**TRI-STATE GENERATION AND TRANSMISSION ASSOCIATION, INC.**

**RE: Colowyo Coal Company L.P.**  
**Permit No. C-1981-019**  
**Technical Revision No. 136**  
**Adequacy Response**

Revision Description: **TR-136 Prospect Pond & D2 Ditch**

Figure Exh. 7-14PP-1  
East Pit Reclamation Sequence

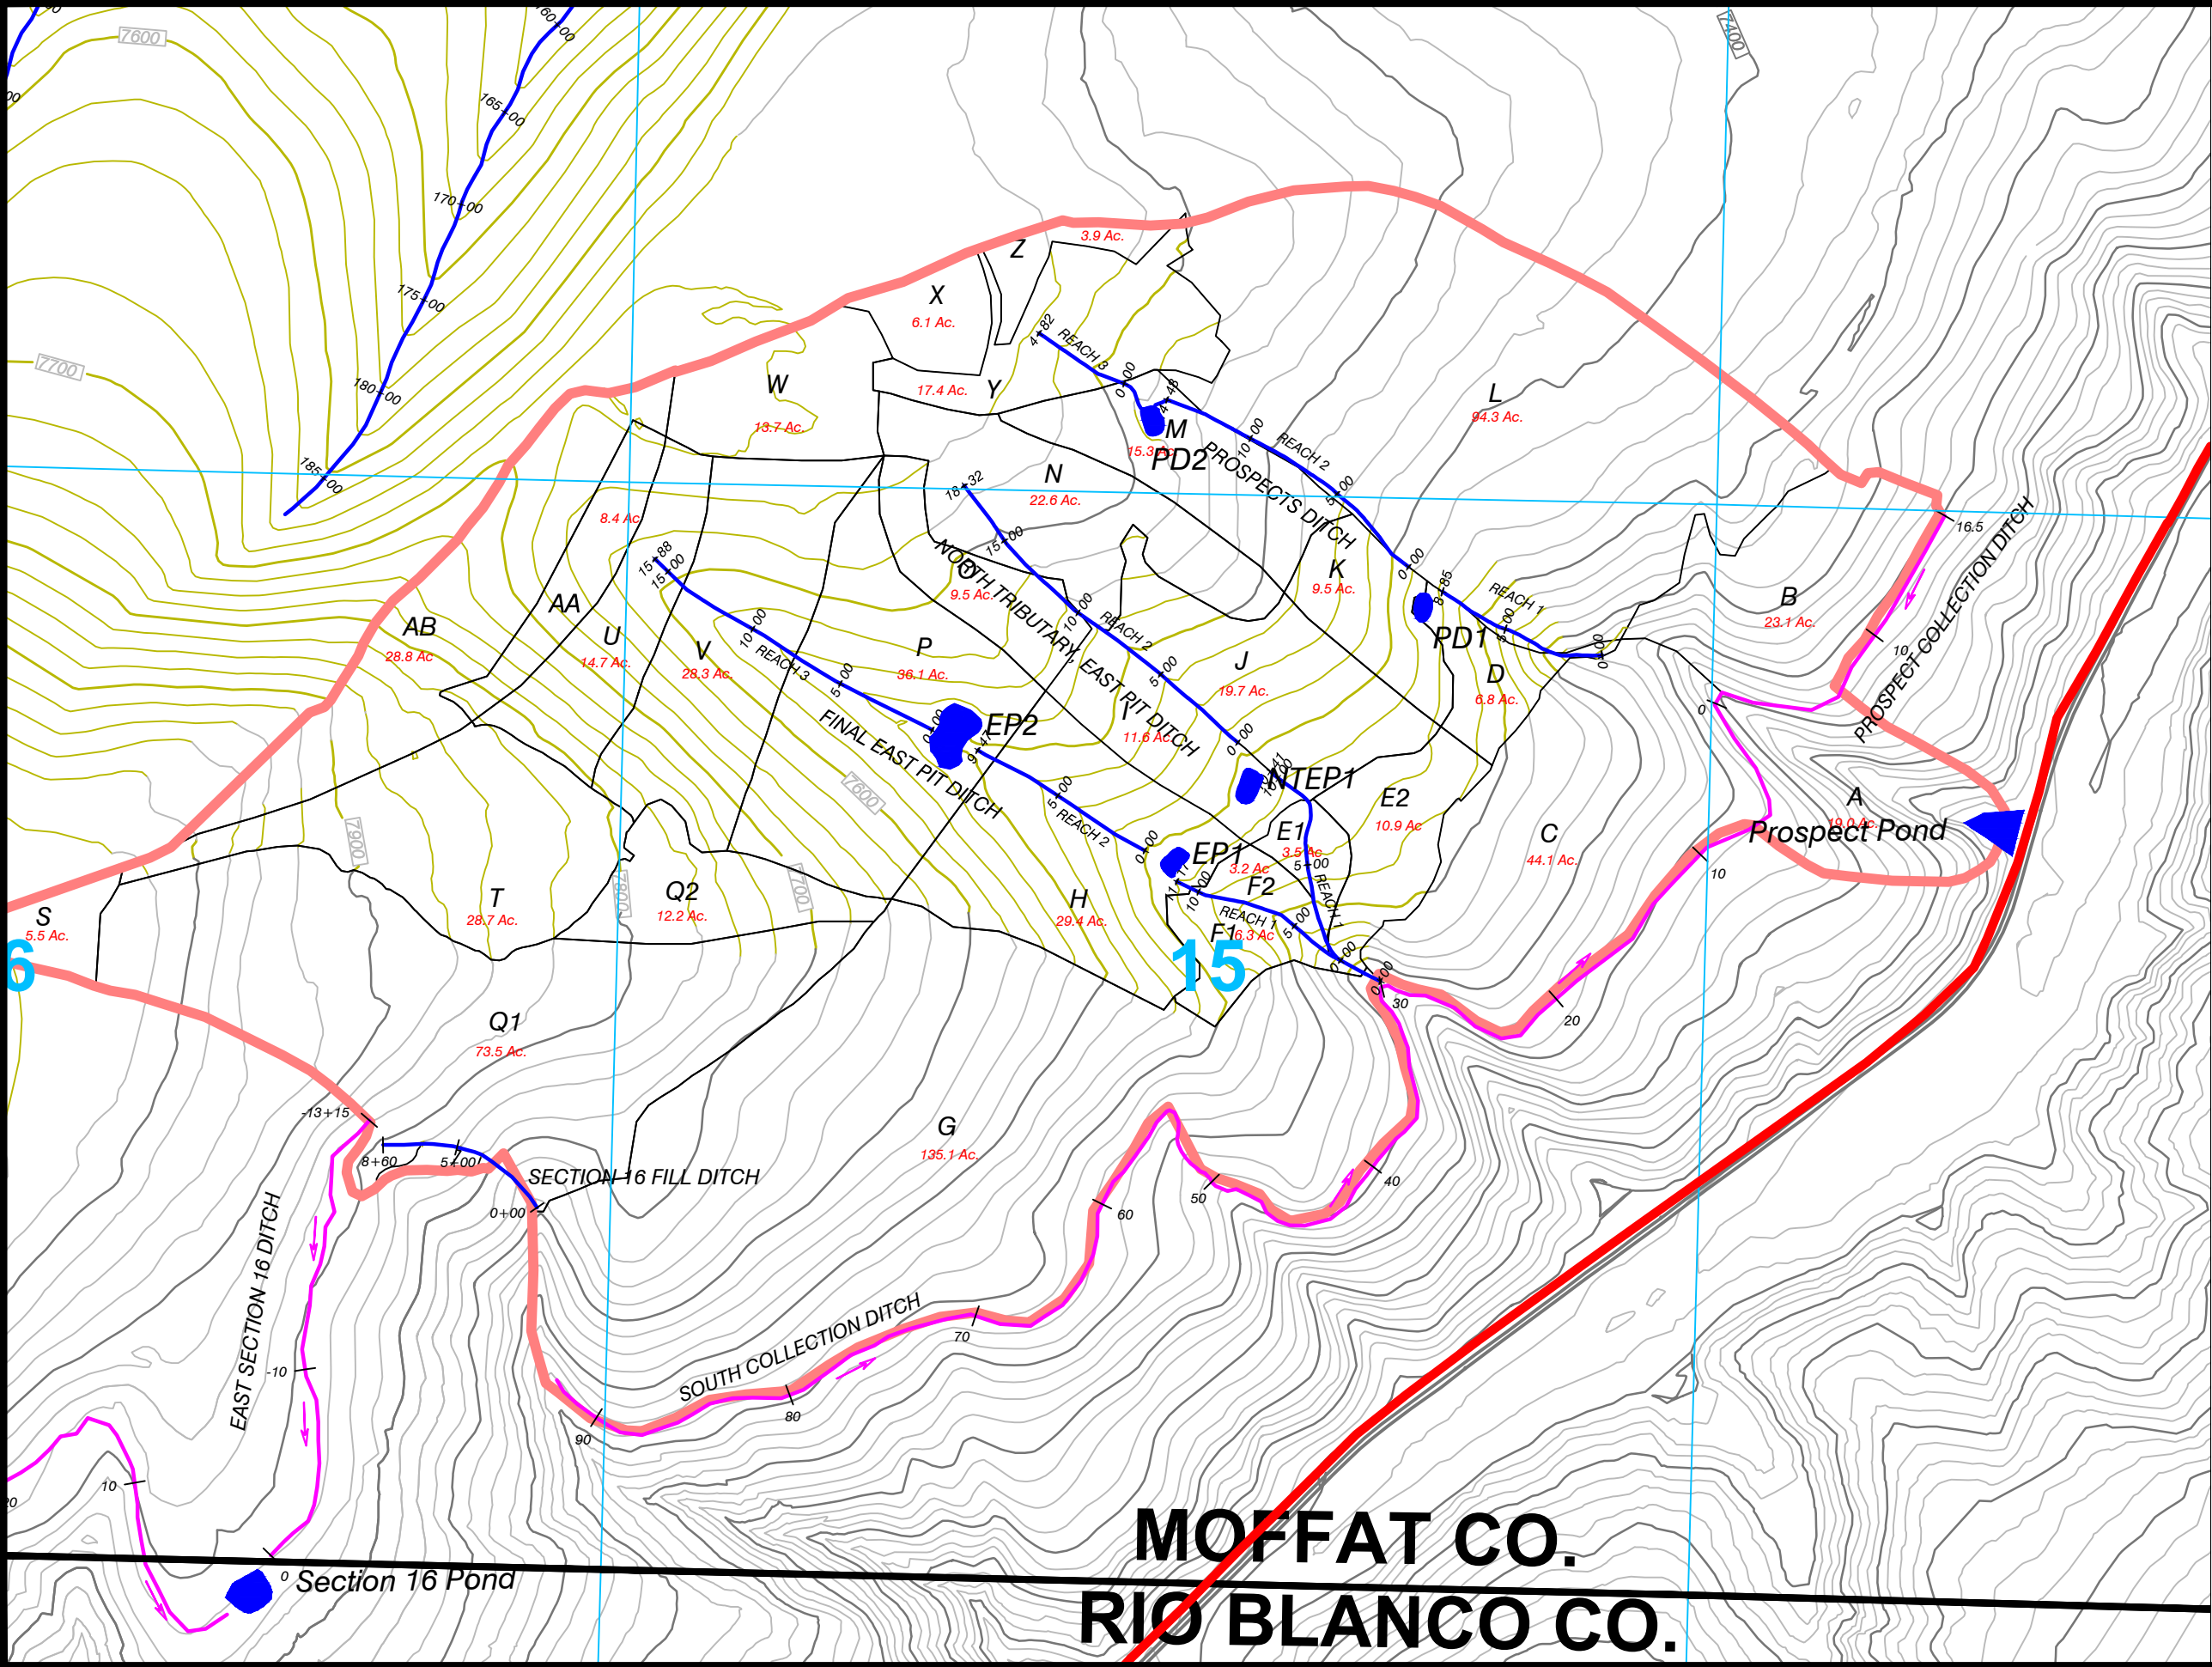
- 3. As requested with the proposed TR-136, all currently approved items within Colowyo's PAP's Volume 2E, Exhibit 7-PP will be updated and replaced. Given the complexities with structure networking and contributing watersheds to the Prospect Pond, the Division's feels that it may be necessary to maintain appropriate figures that are being*

*requested for removal such as Figures Exh. 7-14PP-8 and Figures Exh. 7-14PP-9.  
Please provide updated figures that show the structures and watershed details similarly  
to the above mentioned figures.*

**Response:** Figures Exh. 7-14PP-8 and 7-14-PP-9 have been renumbered to Figures Exh. 7-14PP-1 and 7-14-PP-2, updated accordingly, and provided as requested.
